DOMINION NUCLEAR CONNECTICUT, INC.
MILLSTONE POWER STATION UNIT 2
RESPONSE TO REQUEST FOR ADDITIONAL INFORMATION ON ALTERNATIVE
REQUEST RR-89-61, WELD OVERLAYS OF DISSIMILAR METAL WELDS

**RESPONSE TO REQUEST FOR ADDITIONAL INFORMATION ON
ALTERNATIVE REQUEST RR-89-61, WELD OVERLAYS OF
DISSIMILAR METAL WELDS**

**ALTERNATIVE REQUEST RR-89-61, REVISION 1, USE OF WELD OVERLAYS AS
AN ALTERNATIVE REPAIR AND MITIGATION TECHNIQUE**

(b) Thickness (t_1 and t_2) for Table IWB-3514-2

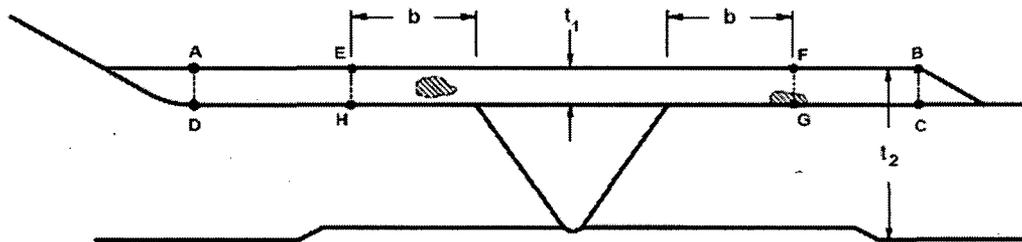
Paragraph 3(a)(3)(a) states that "...In applying the acceptance standards to planar indications the thickness t_1 , t_2 , or t_3 defined in Fig. 1(b) shall be used as the nominal wall thickness in Table IWB-3514-2..." The staff has reservation regarding the definition and concept of t_3 in Figure 1(b) because of the concern on the measurement accuracy and inherent ultrasonic examination uncertainty. Justify the use of the t_3 parameter or eliminate the t_3 definition from paragraph 3(a)(3)(a) and Figure 1(b).

The t_3 parameter will not be used. Paragraph 3(a)(3)(a) of RR-89-61, Revision 1, has been reworded to read: Planar flaws detected in the weld overlay acceptance examination shall meet the preservice examination standards of IWB-3514. In applying the acceptance standards to planar indications, the thickness t_1 or t_2 defined in Fig. 1(b), shall be used as the nominal wall thickness in IWB-3514, provided the base metal beneath the flaw (i.e., safe end, nozzle, or piping material) is not susceptible to stress corrosion cracking (SCC). For susceptible material, t_1 shall be used. If a flaw in the overlay crosses the boundary between the two regions, the more conservative of the two dimensions (t_1 or t_2) shall be used. This requirement is consistent with the latest ASME proposed criteria related to weld overlays with cast stainless steel base material. Additionally, Figure 1(b) has been replaced with a new Figure 1(b) that does not use the t_3 parameter.

FIG. 2 PRESERVICE AND INSERVICE EXAMINATION VOLUME

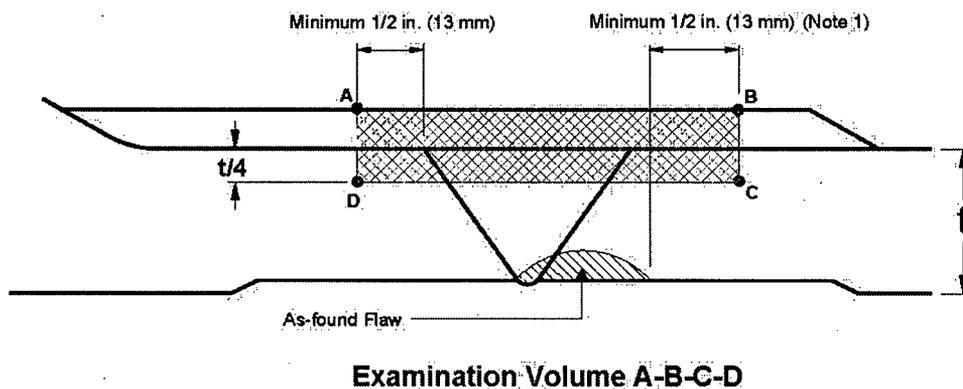
- a. On page 25, Figure 2 of Enclosure 1 is labeled FIG. 2 PRESERVICE AND INSERVICE EXAMINATION VOLUME E-F-G-H. The E-F-G-H should either be deleted or changed to A-B-C-D as shown in the figure.
- b. On page 27, Section I-2 of Mandatory Appendix I states, "...in accordance with Section IX and the requirements of I-1 and I-2." The paragraphs cited should be I-2.1 and I-2.2.
- c. On page 28, Section I-2.1(e) of Mandatory Appendix I cites paragraph I-1(f). The correct paragraph is I-2.1(f).
- d. On page 28, Section I-2.1(f) of Mandatory Appendix I cites paragraph I-1(e). The correct paragraph is I-2.1(e).

All typographical errors have been corrected as identified above.
